PD 24-0722

**Development Services Department**

#### AGENCY REVIEW COMMENT SHEET

**Design Exception for Cowley Road**

2.4 Proposed Site Plan (partial provided below for size and orientation purposes. See Section 8.0 for full site plan)

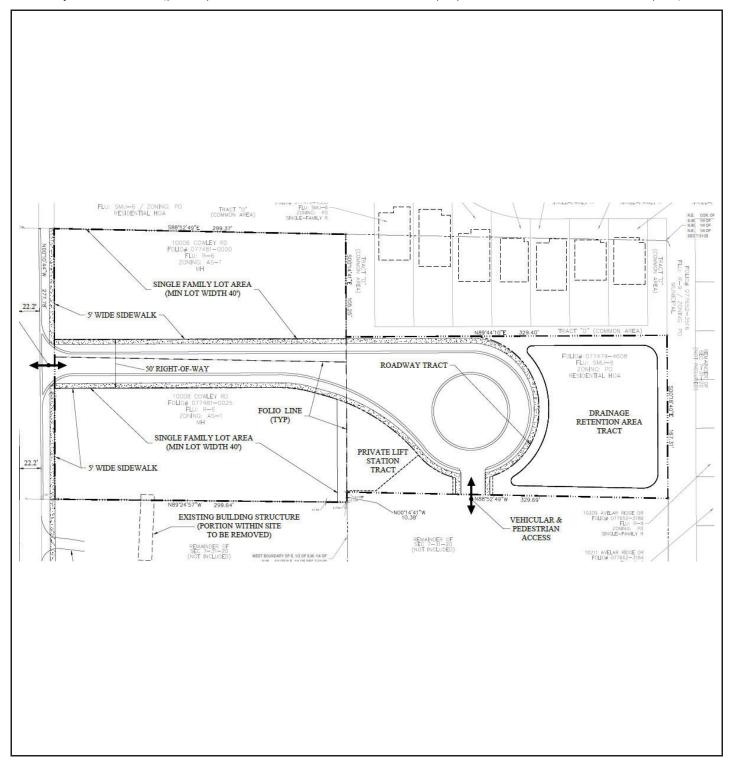
This is a request to rezone a 3.14-acre tract from AS-1 & PD 17-1767 to a Planned Development to facilitate a single-family residential development at a density of 5.1 dwelling unit per acre or sixteen (16) lots. Subject site is composed of three folios and is generally located at 10006 Cowley Road. Surrounding area is primarily residential with the majority of properties developed with single-family homes. Zonings in the vicinity include AS-1, RSC-2 MH, RSC-9 and residential PDs. The nearest commercial and multi-family residential uses lie to east at the intersection of Cowley Road and US Highway 301. More commercial uses are located south of the intersection.

The lot development standards for the proposed Planned Development are like the RSC-10 zoning district with 4,000 square foot lots and a minimum width of 40 feet. The maximum height of the development is proposed to be 36 feet. The density of the development is capped at 5.1 lots per acre and will be allowed a maximum of 16 lots. The development includes the construction of a public roadway with a cul-de-sac turnaround accessing off Cowley Road. A stub out is proposed in the cul-de-sac for a future connection to the south.

- d. Each unit's primary entrance door shall face the roadway.
- 4. The project shall be permitted one full access connection on Cowley Rd. as shown on the PD site plan.

- 5. The project shall construct a roadway stubout to the southern boundary with folio#77481.0100 for future connection, as shown on the PD site plan. Notwithstanding how the roadway stubout is depicted on the PD site plan, the design and dimensions of the stubout shall be consistent with the County Transportation Technical Manual, TS-3 local roadway typical section. In addition to any end-of-way treatment/signage required by the Manual of Uniform Traffic (MUTCD), the developer shall place signage which identifies roadway stub-out as a "Future Roadway Connection".

COWLEY ROAD SITE OFFSITE SIDEWALK PLAN

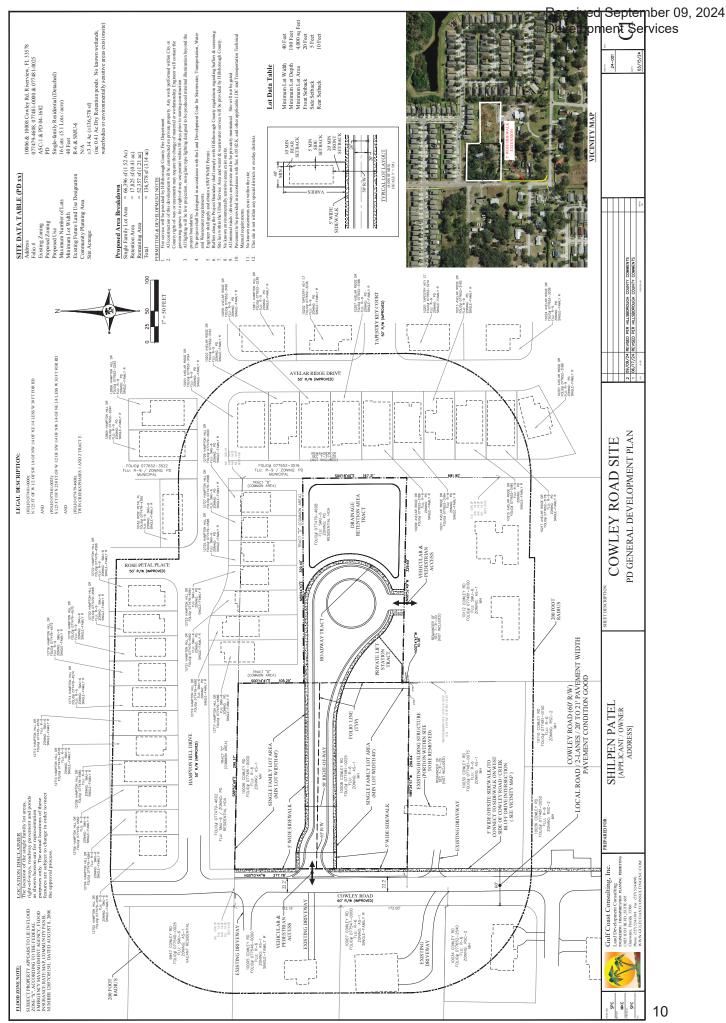
- 2. PROPOSED IMPROVEMENTS The developer proposes constructing approximately 385 linear feet of offsite sidewalk along the east side of Cowley Road and connect to the existing sidewalk on the west side of the Cowley Road / Creek Bluff Drive intersection as shown on the enclosed Offsite Sidewalk Plan Exhibit. See attached PD Plan Exhibit detailing this offsite sidewalk. There are also proposed internal sidewalk improvements which will provide pedestrian access/connectivity from this site, south of this PD property, to Cowley Road.

The Typical Section (TS) for this roadway is assumed to be TS-7 (See TTM). The required right-of-way for the TS-7 is 96 feet. The observed right-of-way of Cowley Road is 60 feet near the site. These measurements and the corresponding requirements of the TS-7 are shown in the table below (All measurements are approximate and vary along the roadway.):

I have found the attached Design Exception (DE) for PD 24-0722 APPROVABLE.
